APPROVALS		TITLE: BACKLINE 250 POWER AMP	
INIT	DATE	REV	DRAWING NO:
DESIGNED: R.A.G.	12/3/00	B	406-0108-A
DRAWN: R.A.G.	3/04/02		PART NO: 206-0108-A
ELEC:			
MECH:		COMPANY:	GALLIEN-KRUEGER
Q/A:		FILENAME:	60108A
RELEASED:

Customer Name:	Gallien-Krueger	Current Rev #:	A00	New ECO Rev #:	A01
Model:	Backline 250 / Backline 115			Page:	1 Of: 1
Assembly Description:	Power Amp. Module	Originator:	R. Gallien		
Assembly Numbers:	206-0108-A	Approved by:			
		Effective Date:	2/26/2002		
Effective		Document Update		Date	Initials
<input checked="" type="checkbox"/>	All in Process	<input checked="" type="checkbox"/>	Artwork		
<input checked="" type="checkbox"/>	All in Service	<input checked="" type="checkbox"/>	Assembly Dwg.		
<input checked="" type="checkbox"/>	All in Stock	<input type="checkbox"/>	Board Artwork		
Beginning Serial Number:		<input checked="" type="checkbox"/>	BOM		RAG
Reason For Change		<input type="checkbox"/>	Control Form		
Update fuse from F2.5A to T2.5A. Time lag is required to withstand inrush at turn on.		<input type="checkbox"/>	Costing		
Add new fuse label to power amp marked: 100-120V:T2.5A/250V Semko For 100 and 120V models.		<input type="checkbox"/>	Fab Drawing

TI

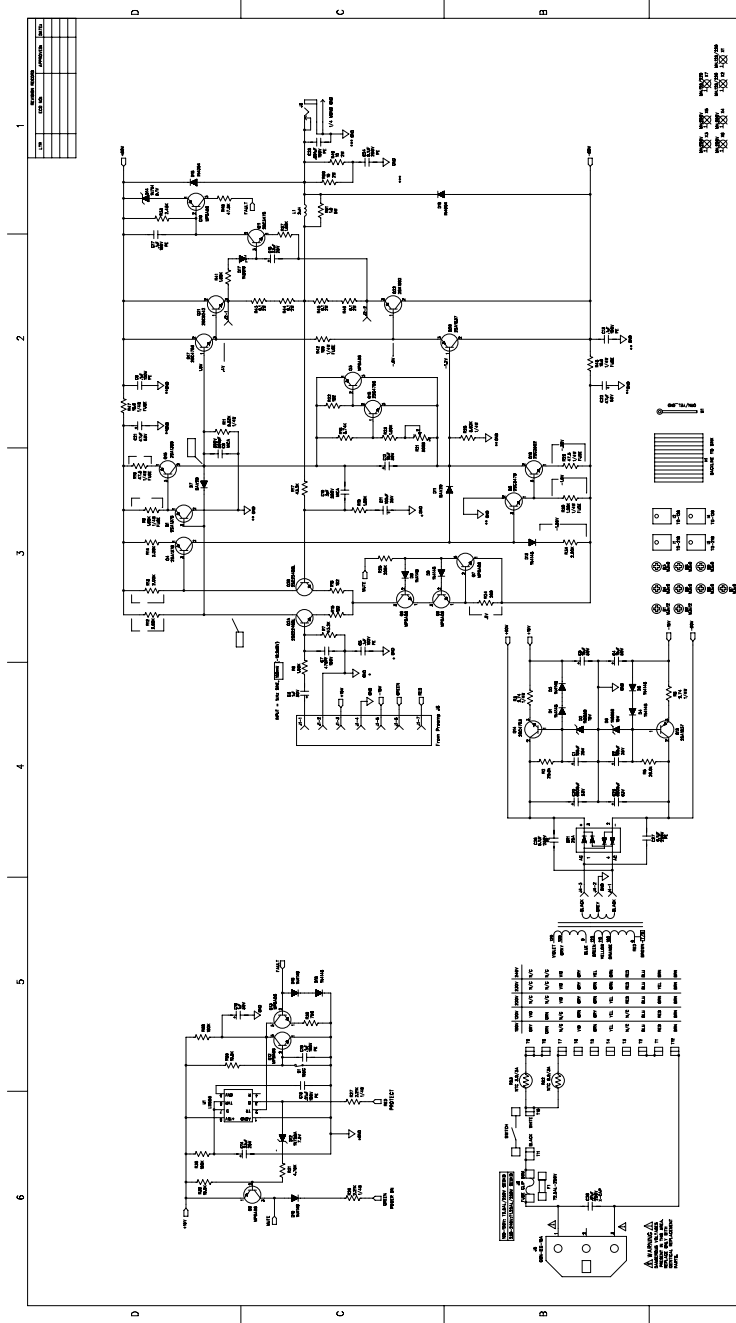
1. Fuse spec changed to T2.5A/250V Semko

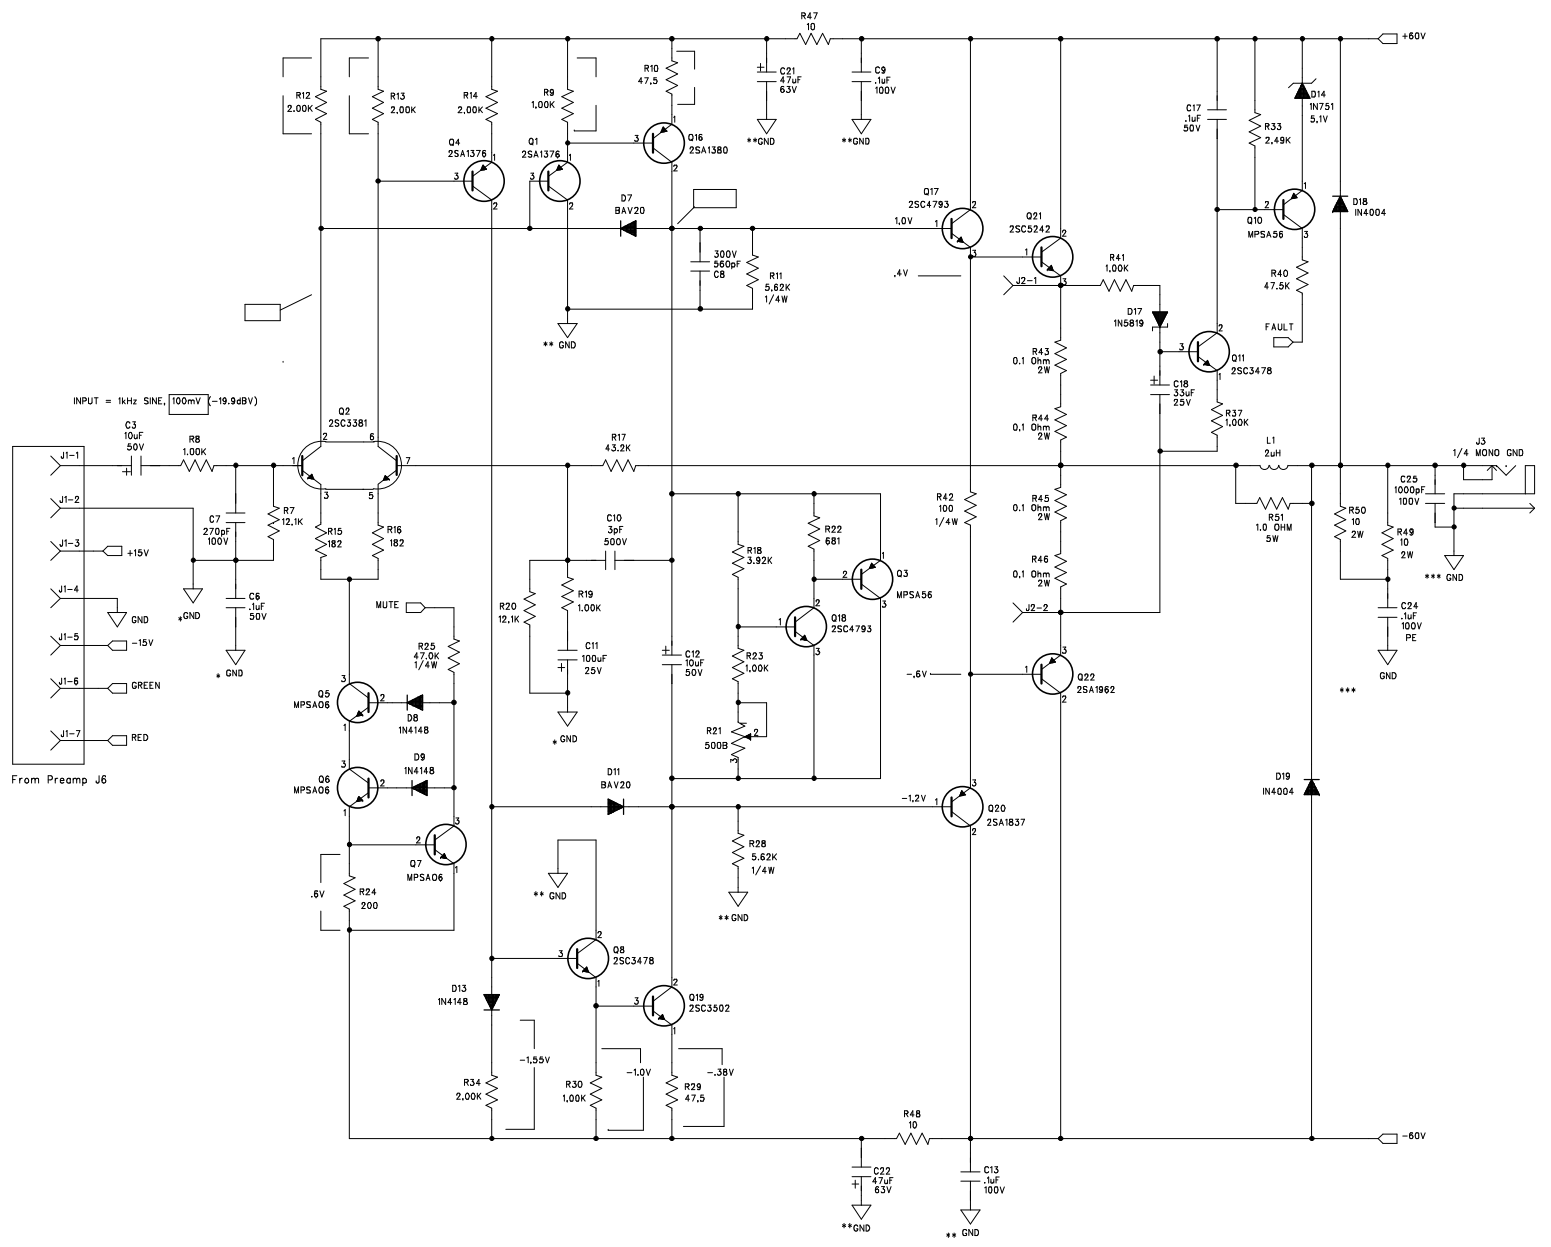
1. Changed R18 from 3.74K to 3.92K. 2. Changed R22 from 6.81K to 681 ohms.		APPROVALS		TITLE: BACKLINE 250 POWER AMP	
DESIGNED: R.A.G.	DATE: 12/3/00	INIT	DATE	REV	DRAWING NO: 406-0108-A1
DRAWN: R.A.G.	DATE: 3/04/02			B	PART NO: 206-0108-A1
ELEC:					REV: A1
MECH:					
Q/A:					COMPANY: GALLIEN-KRUEGER
RELEASED:					FILENAME: 60108A1

Customer Name:		Gallien-Krueger		Current Rev #:		A01		New ECO Rev #:		A02	
Model:		Backline 250/Backline 115				Page:		1		Of: 1	
Assembly Description:		Power Amp module		Originator:		A. T. Millet					
Assembly Numbers:		206-0108-A		Approved by:							
				Effective Date:		7/31/2002					
Effective				Document Update				Date		Initials	
<input checked="" type="checkbox"/>	All in Process	<input type="checkbox"/>	Next Buy	<input type="checkbox"/>	Artwork						
<input checked="" type="checkbox"/>	All in Service	<input checked="" type="checkbox"/>	Next Production Run	<input type="checkbox"/>	Assembly Dwg.						
<input checked="" type="checkbox"/>	All in Stock	<input type="checkbox"/>		<input type="checkbox"/>	Board Artwork						
Beginning Serial Number:				<input checked="" type="checkbox"/>	BOM						RAG
Reason For Change				<input type="checkbox"/>	Control Form						
To make the bias voltage more stable at any change in temperature.				<input type="checkbox"/>	Costing

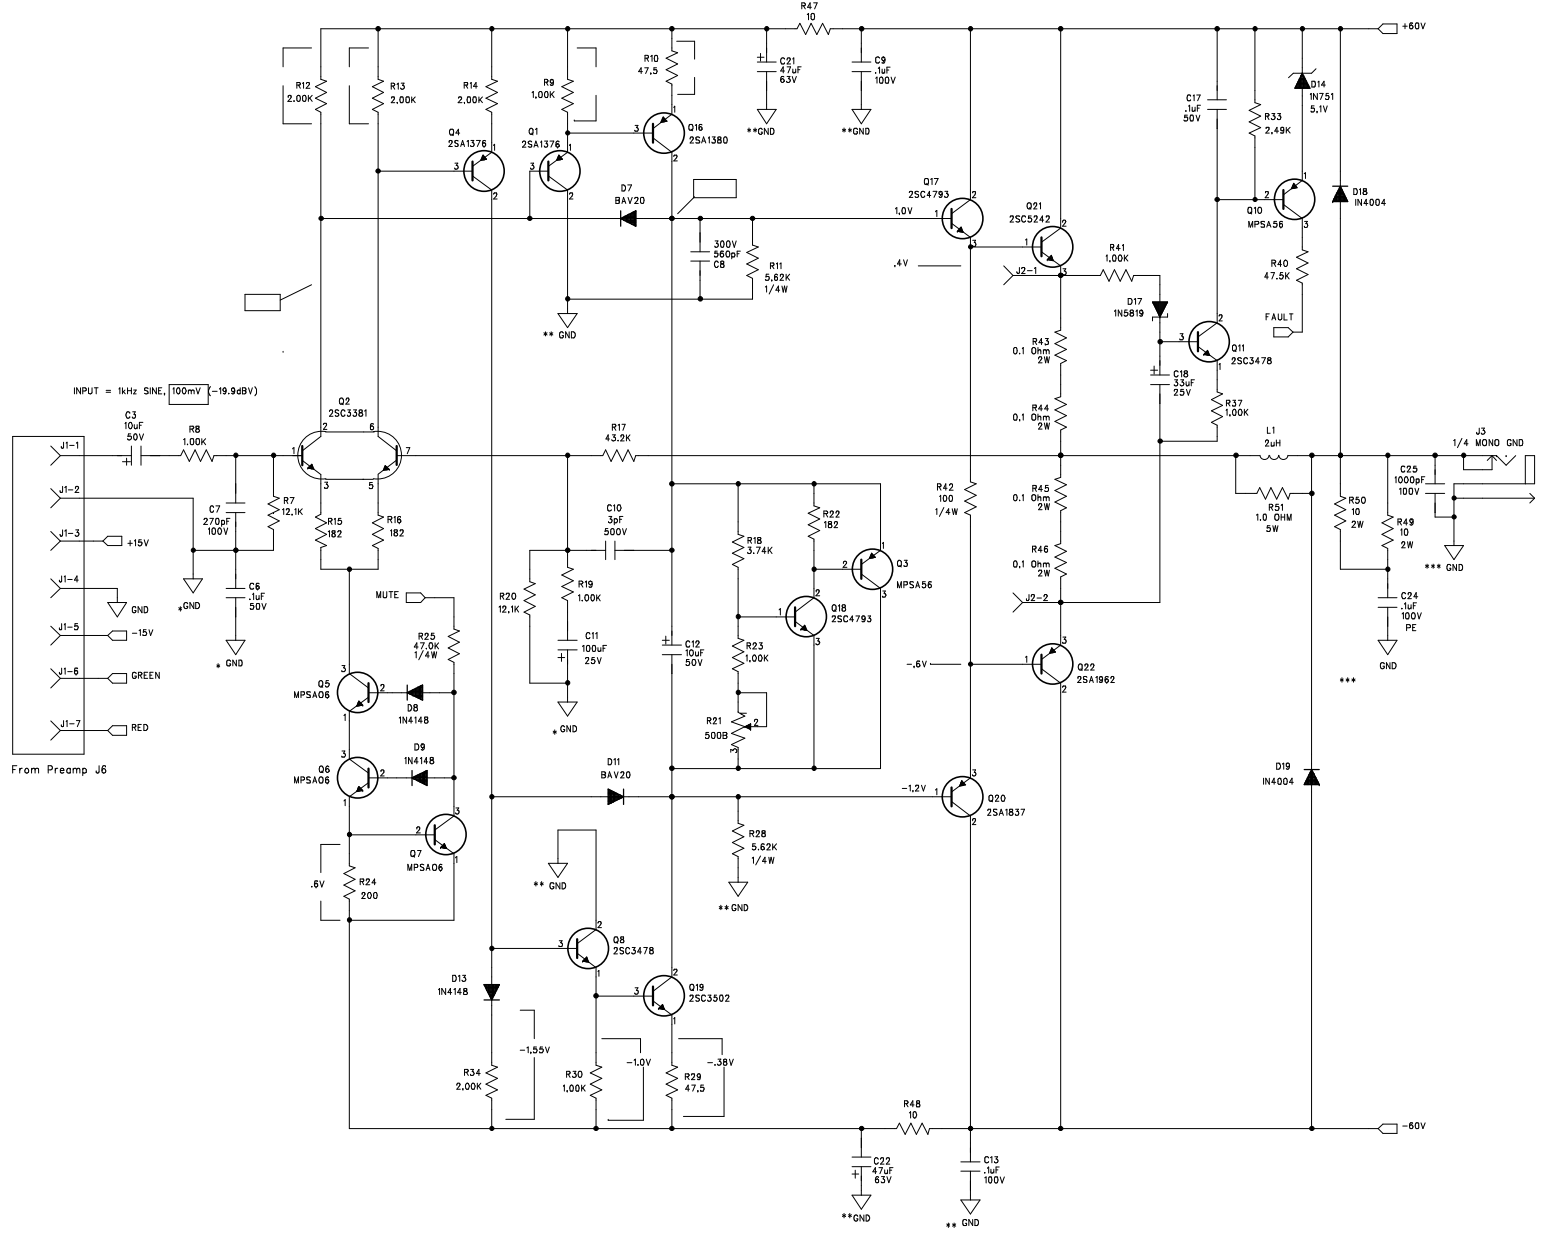
<input checked="" type="checkbox"/>	Production Eng.						
				<input checked="" type="checkbox"/>	Purchasing						
				<input type="checkbox"/>	Q.A.						
				<input type="checkbox"/>	Receiving						
				<input checked="" type="checkbox"/>	Service						
				<input checked="" type="checkbox"/>	Test						
				<input type="checkbox"/>	Vendor						
				<input type="checkbox"/>							
				<input type="checkbox"/>							
<input type="checkbox"/> Continued on ECO Supplement Page											
<input type="checkbox"/> Drawing(s) attached											
Part Number	Description	Parts Added		Parts Deleted							
		Qty	Ref. Designator	Qty	Ref. Designator						
060-6812-0	6.81K,1/8W,res.	0		1	R22						
060-1821-0	182,1/8W,res.	1	R22	0

NOT VALID UNLESS STAMP IS RED				2240 PARAGON DRIVE SAN JOSE CA. 95131 VOICE: 408-441-8081 FAX: 408-441-8085
NOTES FOR ECO A02: 1. CHANGED R22 TO 182.				TITLE: BACKLINE 250 POWER AMP
APPROVALS		DATE: 12/3/00 DATE: 3/04/02		
DESIGNED:	R.A.G.	SIZE:	DRAWING NO: 406-0108-A2	
DRAWN:	R.A.G.	REV.:	PART NO: 206-0108-A2	
ELEC:				
MECH:		COMPANY:	GALLIEN-KRUEGER	
Q/A:		FILENAME:	60108A2	
RELEASED:

APPROVALS		DATE	TITLE
INIT	R.A.G.	12/3/00	BACKLINE 115 POWER AMP
DRAWN:	R.A.G.	9/27/02	DRAWING NO: 406-0108-B
ELEC:			PART NO: 206-0108-B
MECH:			COMPANY: GALLIEN-KRUEGER
Q/A:			FILENAME: 60108B
RELEASED:

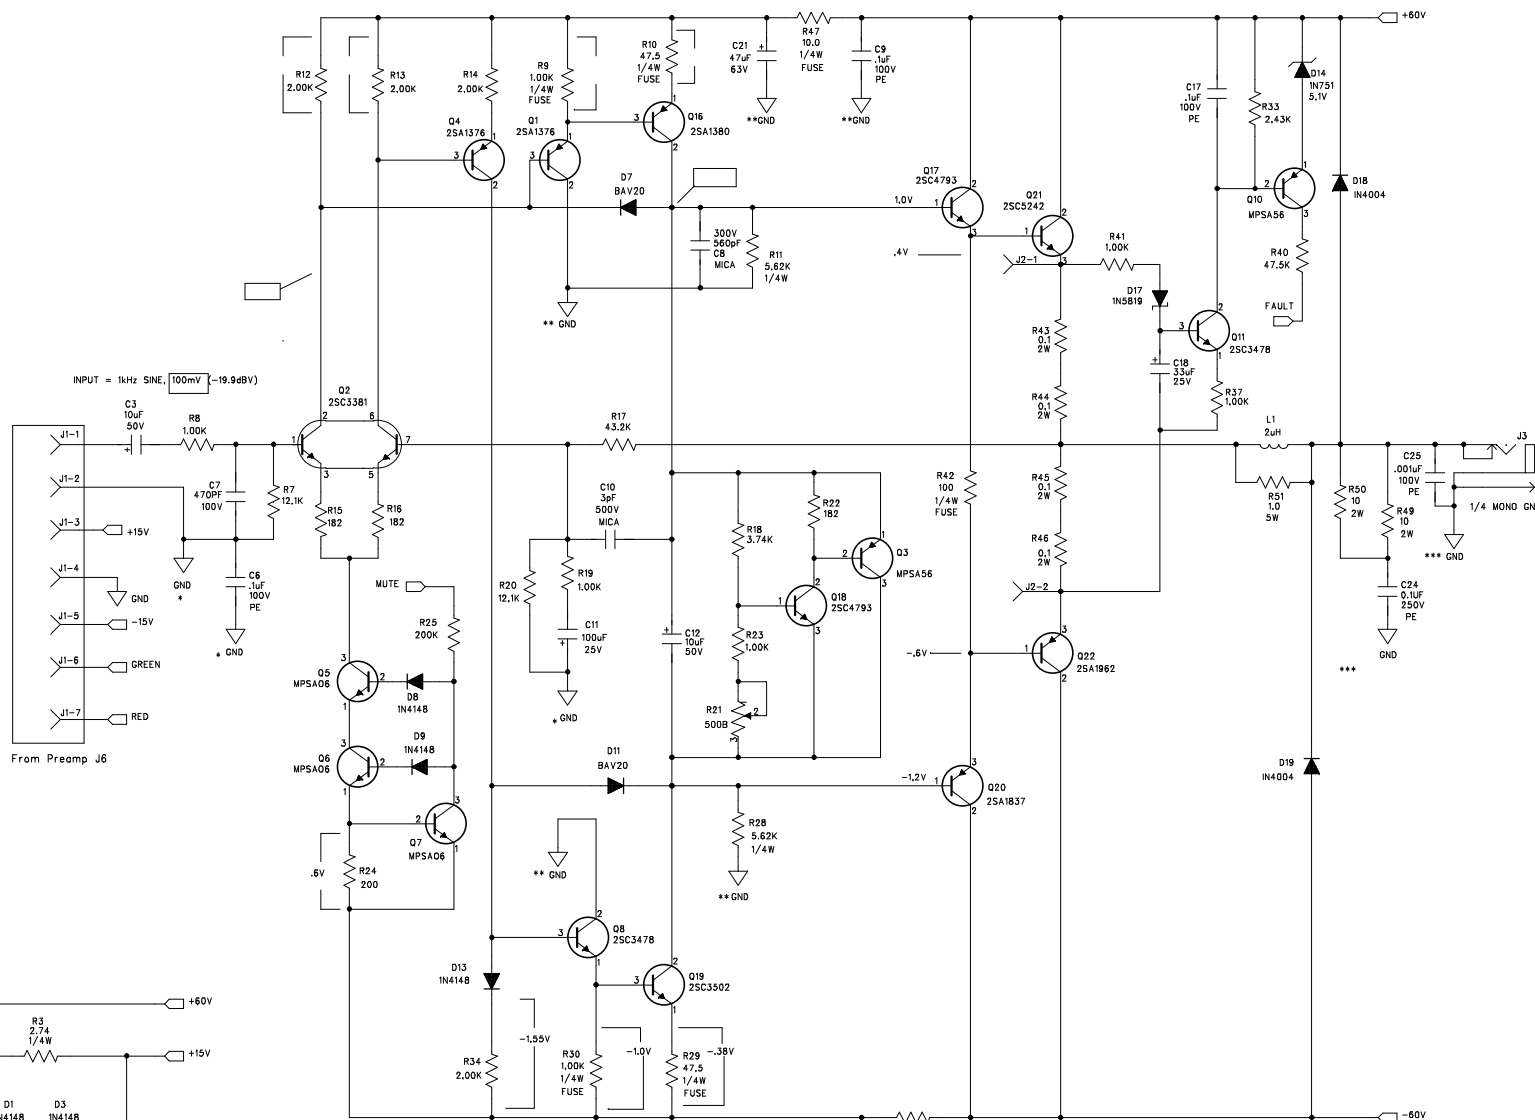
<input checked="" type="checkbox"/>	Production Eng.		
		<input checked="" type="checkbox"/>	Purchasing		
		<input type="checkbox"/>	Q.A.		
		<input type="checkbox"/>	Receiving		
		<input type="checkbox"/>	Service		
		<input checked="" type="checkbox"/>	Test		
		<input type="checkbox"/>	Vendor		
		<input type="checkbox"/>			
		<input type="checkbox"/>			
<input type="checkbox"/>	Continued on ECO Supplement Page				
<input type="checkbox"/>	Drawing(s) attached				
Part Number	Description	Parts Added		Parts Deleted	
		Qty	Ref. Designator	Qty	Ref. Designator
030-4271-0	270pf 100V capacitor			1	C7
034-4471-0	470pf 100V capacitor	1	C7		
060-1000-0	10 ohms 1/8 watt resistor			2	R1, R4

- NOTES FOR ECO B:
- CHANGED ALL AXIAL CER TO POLYESTER.
 - CHANGE CRITICAL RESISTORS TO FUSE TYPE.
 - C7 470 pF.
 - REMOVE R14 (REV A2)

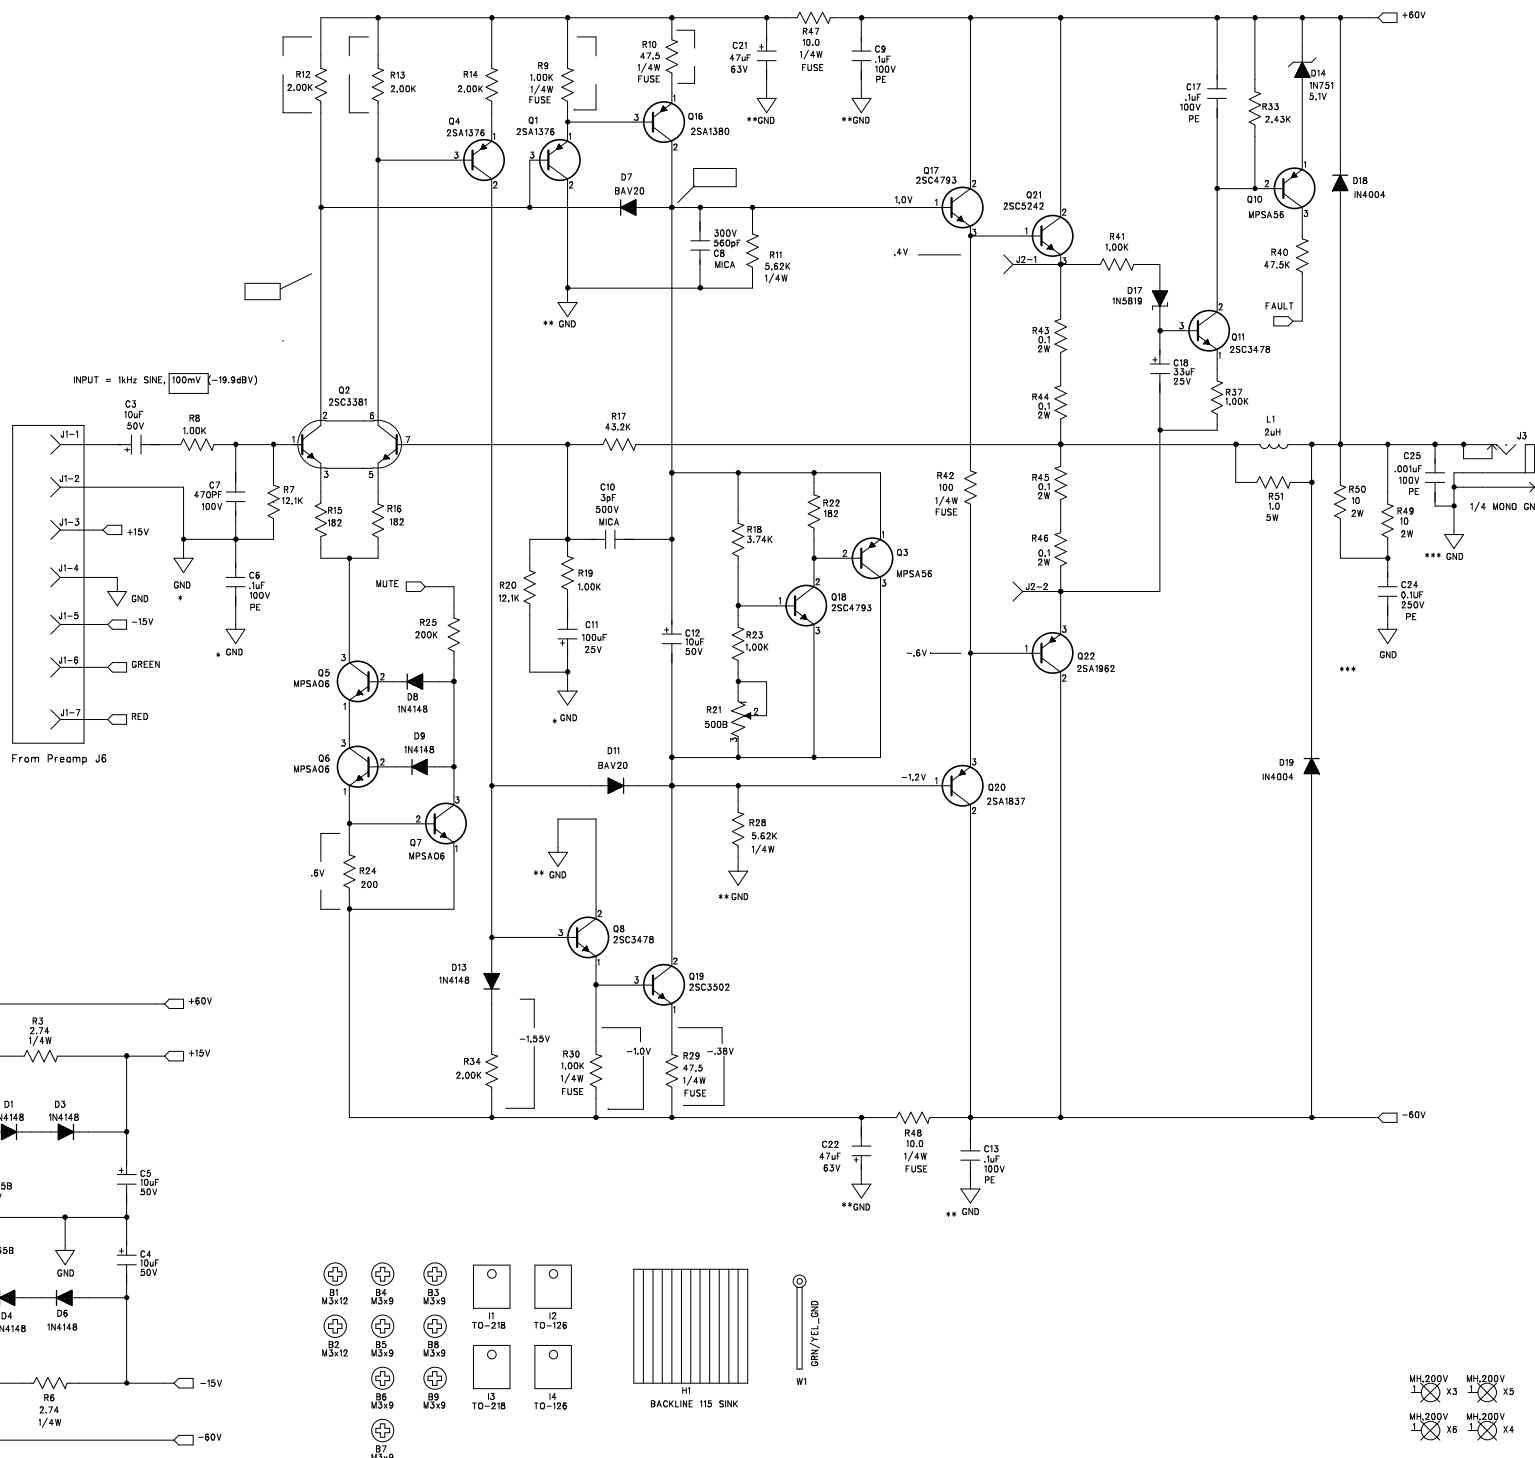
NOTES FOR ECO B:		APPROVALS		TITLE:	
1. UPDATED PAD AND HOLE SIZES.	2. CHANGED BOARD NO. TO 206-0180-A FROM 206-0108-B	INIT	DATE	BACKLINE 115 POWER AMP	
		DESIGNED: R.A.G.	12/3/00	DRAWING NO:	406-0180-A
		DRAWN: R.A.G.	12/8/02	PART NO:	206-0180-A
		ELEC:		REV:	A
		MECH:		COMPANY:	GALLIEN-KRUEGER
		Q/A:		FILENAME:	60180A
		RELEASED:
